#### BERGENFIELD ZONING BOARD OF ADJUSTMENT REGULAR MEETING TELECONFERENCE VIA CISCO WEBEX MAY 4, 2020 8:00 PM

### RE: 450 South Washington Avenue Block 352 Lot 5 Change of use in B2 Zone for proposed Indoor Recreational Trampoline Park (SkyZone) Jarmel Kizel Project Number: PREETHI-S-20-088

The Applicant is in receipt of a review letter dated February 27, 2020 prepared by Bright View Engineering (BVE). The following details our responses to the comments presented in the BVE correspondence. For ease of review, each comment is repeated in *italics* and our responses are in **bold**.

**RE: Addition**

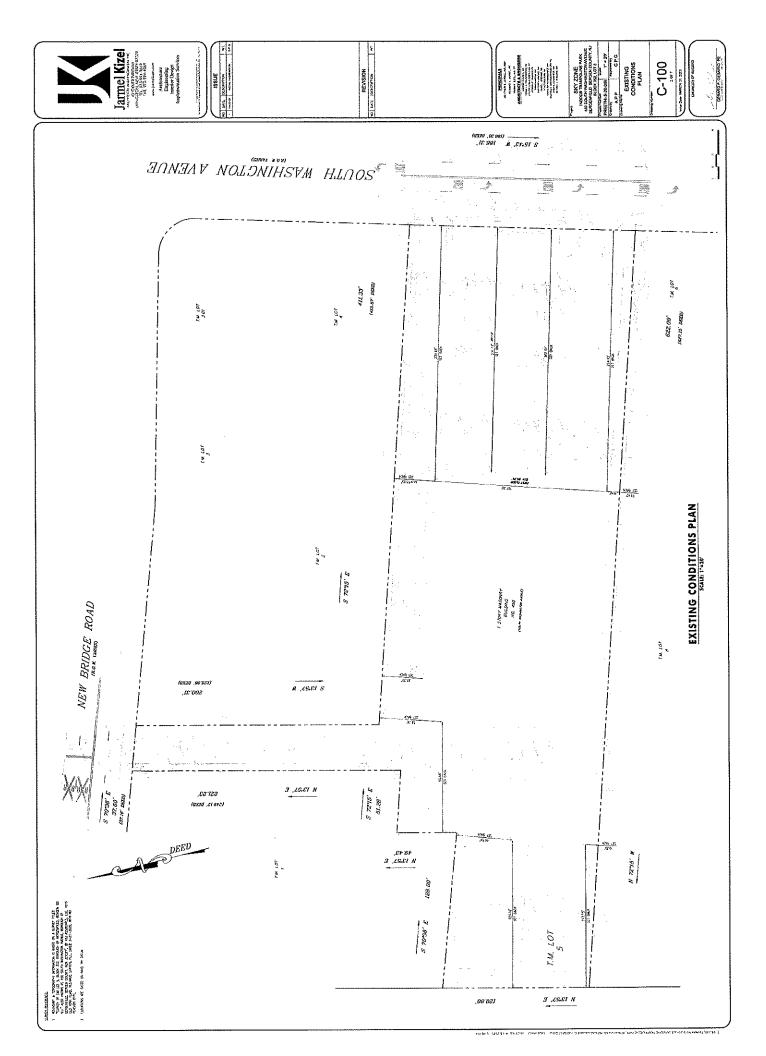
Your application for an addition has been denied for the following reasons:

- 1. Required lot coverage 35% or 1,865.5 sq. feet. Proposed lot coverage 38.37% or 2,045 sq. feet.
- 2. Required improved lot coverage 40% or 2,132 sq. feet. Proposed improved lot coverage 52.6% or 2,807 sq. feet.
- 3. 10% credit for pavers minus 76.26 sq. feet equal 2,730 sq. feet or 51.22%
